# UNITED STATES PATENT AND TRADEMARK OFFICE

APPLICATION NO.	FILING DATE	FIRST NAMED INVENTOR	ATTORNEY DOCKET NO.	CONFIRMATION NO.
10/037,325	01/03/2002	Harry W. Eberle III	(HWE-107A)	5841
7590 06/14/2004 KENNETH P. GLYNN, ESQ. Glynn & Associates, P.C. 24 Mine Street Flemington, NJ 08822			EXAMINER GARCIA, ERNESTO	
			ART UNIT 3679	PAPER NUMBER

**Office Action Summary**

### **DETAILED ACTION**

3,319,983 (Zibell)

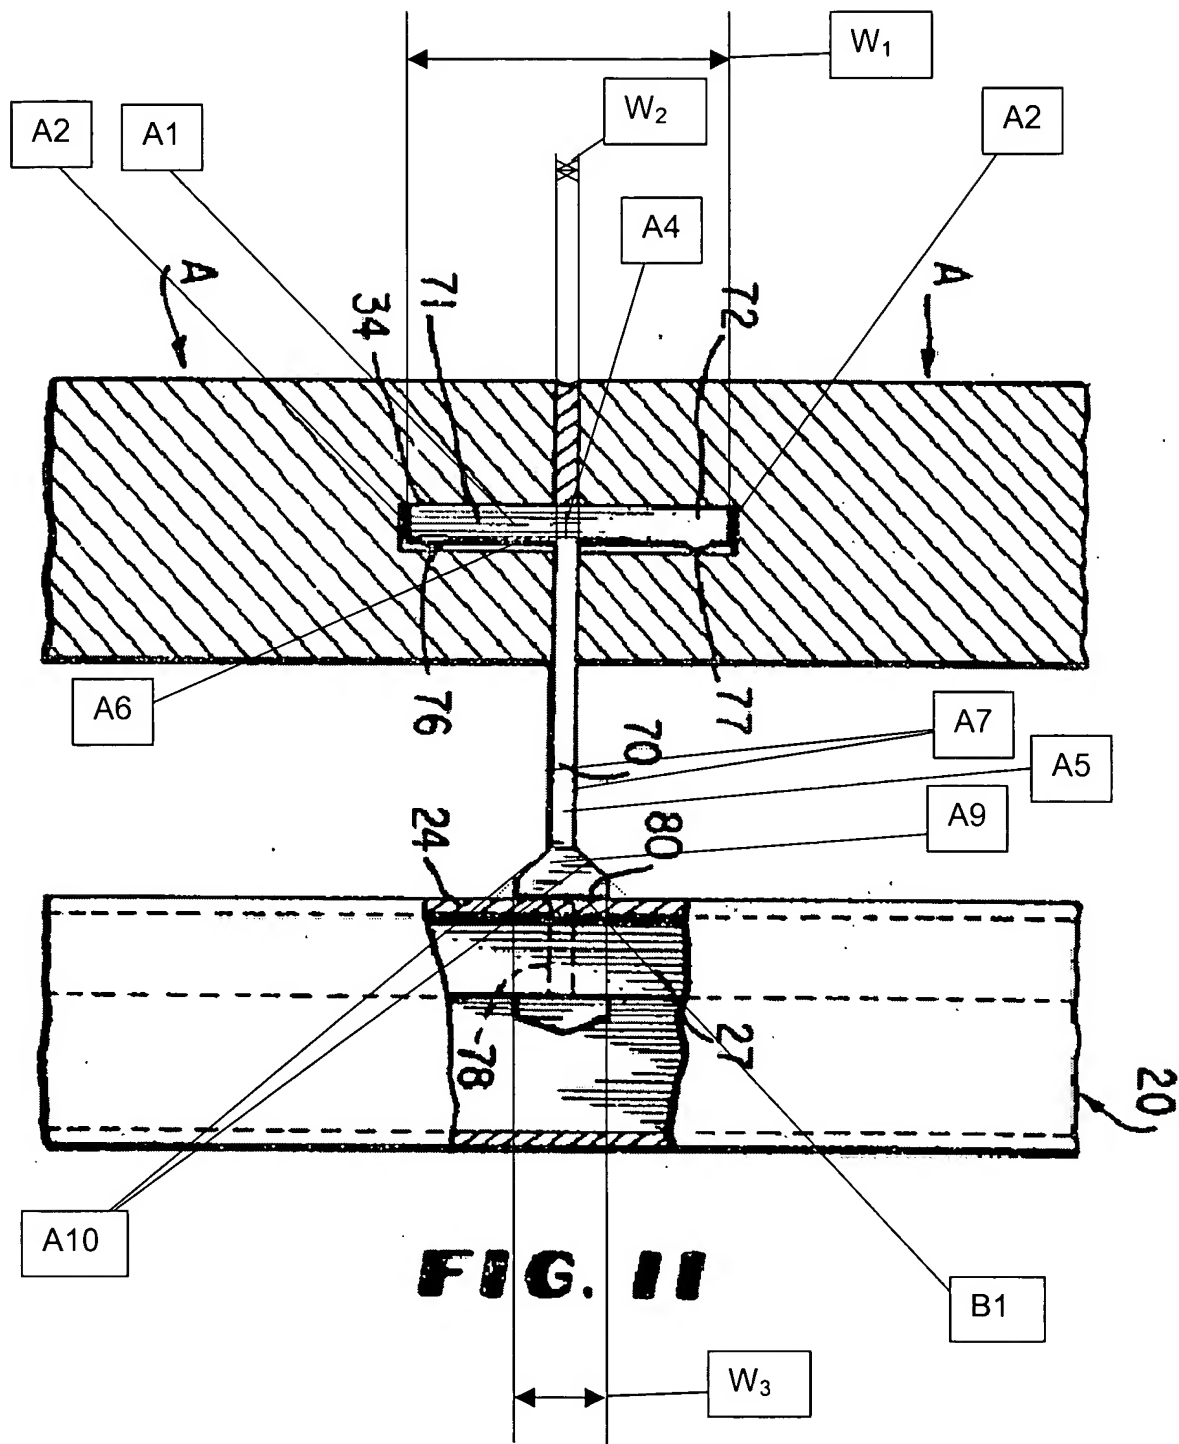
Claim 21 is rejected under 35 U.S.C. 102(b) as being anticipated by Zibell, 3,319,983 (see marked-up attachment).

Regarding claim 21, Zibell discloses in Figure 11, an anchoring device comprising a substantially flat horizontal top element **A1**, at least one substantially vertical support member **A5**, and a substantially flat horizontal bottom element **A9**. The top element **A1** has a top view configuration including two sides **A2** and a predetermined first width **W<sub>1</sub>** as measured side to side. The first width **W<sub>1</sub>** is measured at a maximum width between the sides **A2**. The top element **A1** has an imaginary center line **A4**. The support member **A5** is attached to an underside **A6** of the top element **A1** along the center line **A4** and the support member **A5** extends downwardly therefrom. The support member **A5** has two sides **A7** and a predetermined second

width **W<sub>2</sub>** as measured side to side at a maximum width. The bottom element **A9** has a flat bottom view configuration which includes sides **A10** and having a generally trapezoidal shape, and a predetermined third width **W<sub>3</sub>** as measured side to side at a maximum width at a trapezoidal base **B1**. The first width **W<sub>1</sub>** is greater than the second width **W<sub>2</sub>** and the third width **W<sub>3</sub>**. The third width **W<sub>3</sub>** is greater than the second width **W<sub>2</sub>**.

5,704,181 (Fisher et al.)

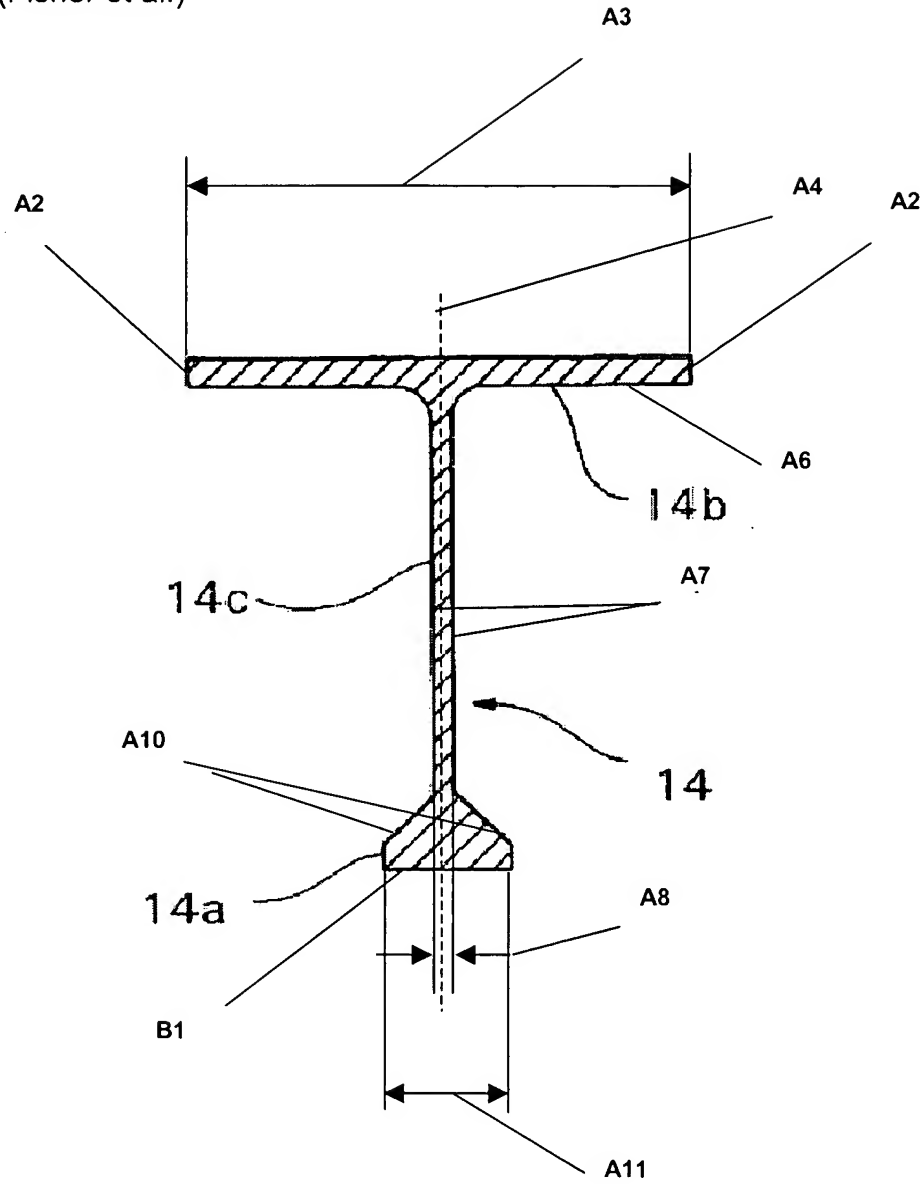
Claim 21 is rejected under 35 U.S.C. 102(b) as being anticipated by Fisher et al., 5,704,181 (see marked-up attachment).

Regarding claim 21, Fisher et al. disclose, in Figure 3, an anchoring device comprising a substantially flat horizontal top element **14b**, at least one substantially vertical support member **14c**, and a substantially flat horizontal bottom element **14a**.

The top element **14b** has a top view configuration including two sides **A2** and a predetermined first width **A3** as measured side to side. The first width **A3** is measured at a maximum width between the sides **A2**. The top element **14b** has an imaginary center line **A4**. The support member **14c** is attached to an underside **A6** of the top element **14b** along the center line **A4** and the support member **14c** extends downwardly therefrom. The support member **14c** has two sides **A7** and a predetermined second width **A8** as measured side to side at a maximum width. The bottom element **14a** has a flat bottom view configuration which includes sides **A10** and having a generally trapezoidal shape, and a predetermined third width **A11** as measured side to side at a maximum width at a trapezoidal base **B1**. The first width **A3** is greater than the second width **A8** and the third width **A11**. The third width **A11** is greater than the second width **A8**.

556,998 (Major)

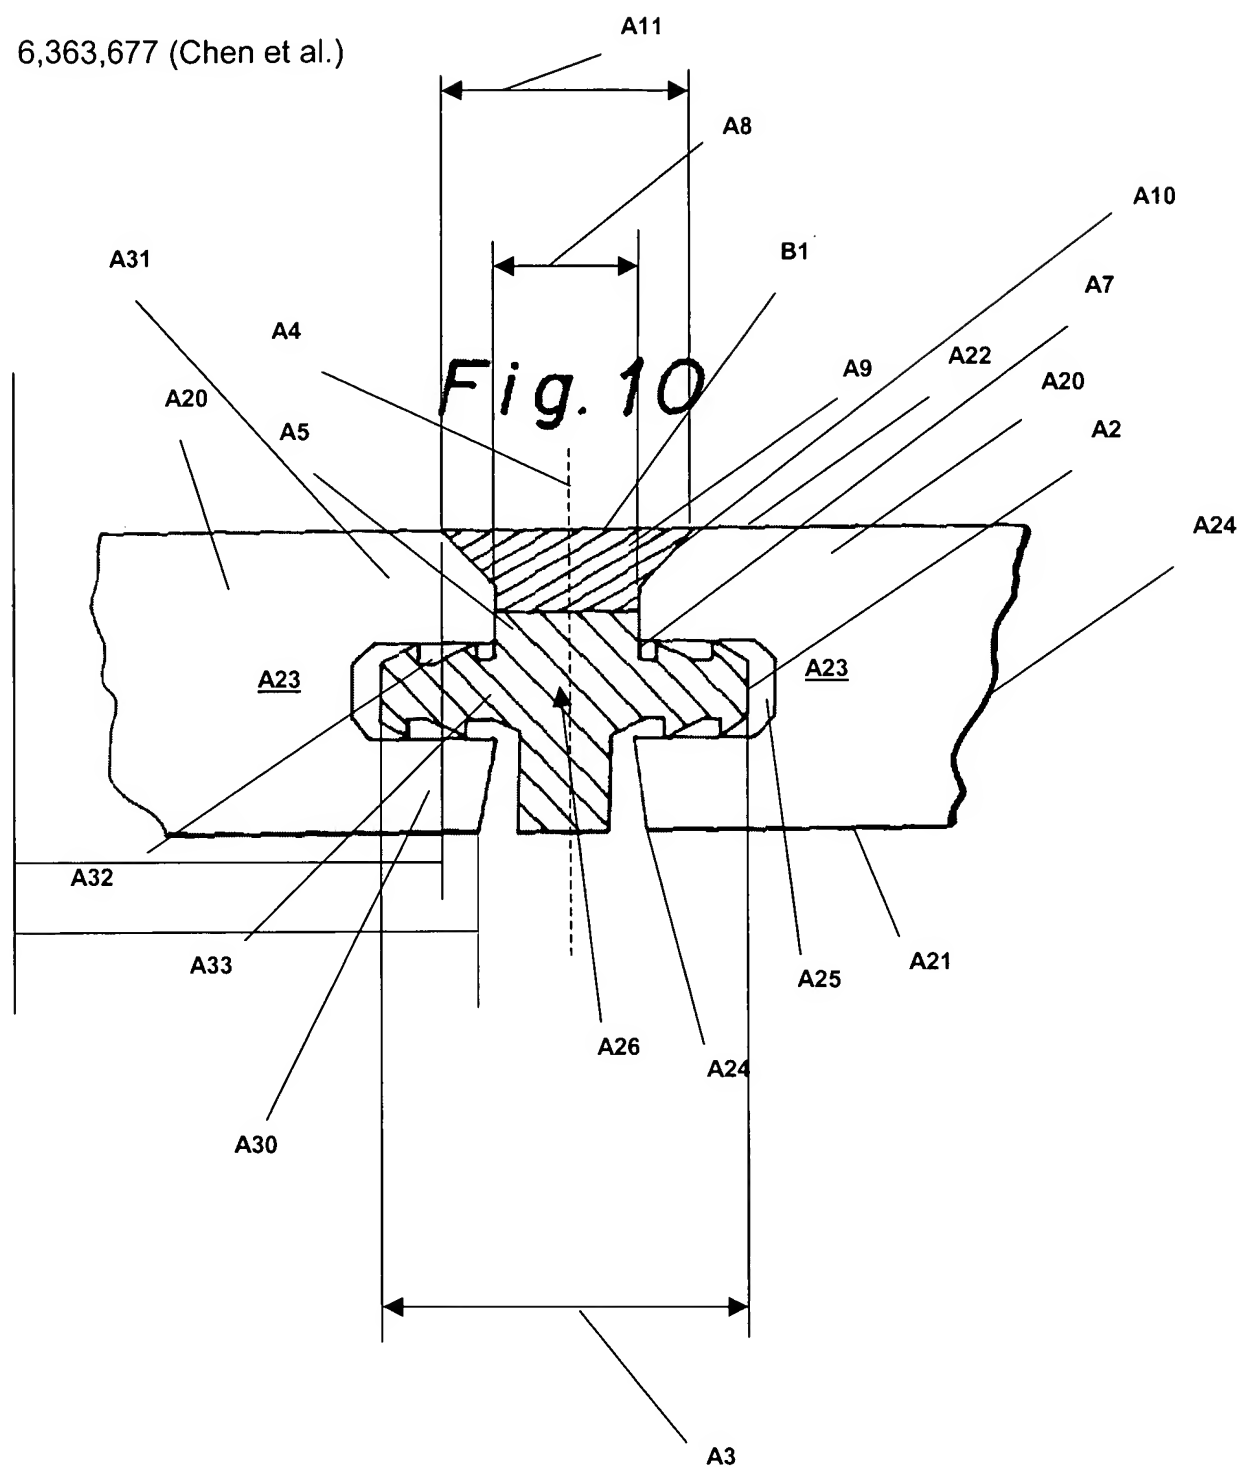
Claim 24 is rejected under 35 U.S.C. 103(a) as being unpatentable over Major, 556,998 (see marked-up attachment), in view of Fisher et al., 5,704,181.

Regarding claim 24, Major, discloses, in Figure 1, a decking system comprising boards **B** and an anchoring device **A**. Each of the boards **B** has a top **e**, a bottom **c**, two sides **12** and two ends (Fig. 2A). At least one groove **l** is located along one of the sides **12**. The device **A** comprises a substantially flat horizontal top element **k**, at least one substantially vertical support member **A5**, and a substantially flat horizontal bottom

element **A9**. The top element **k** has a top view configuration including two sides **A2** and a predetermined first width **A3** as measured side to side. The first width **A3** is measured at a maximum width between the sides **A2**. The top element **k** has an imaginary center line **A4**. The support member **A5** is attached to an underside **A6** of the top element **k** along the center line **A4** and the support member **A5** extends downwardly therefrom. The support member **A5** has two sides **A7** and a predetermined second width **A8** as measured side to side at a maximum width. The bottom element **A9** has a flat bottom view configuration which includes sides **A10**, and a predetermined third width **A11** as measured side to side at a maximum width at a base. The first width **A3** is greater than the second width **A8** and the third width **A11**. The third width **A11** is greater than the second width **A8**.

However, Major, fails to disclose, the bottom element **A9** having a generally trapezoidal shape. Fisher et al. teach, in Figure 3, a bottom element **14a** of an anchoring device comprising a trapezoidal shape to have a dissymmetric anchoring device so that it increase load-bearing capacity (col. 4, lines 17-36). Therefore, as taught by Fisher et al., it would have been obvious to one of ordinary skill in the art at the time the invention was made to configure the bottom element having a generally trapezoidal shape so that the anchoring device has a dissymmetric shape to increase load-bearing capacity. Note, the base will be a trapezoidal base due to the horizontal bottom element having a trapezoidal shape.
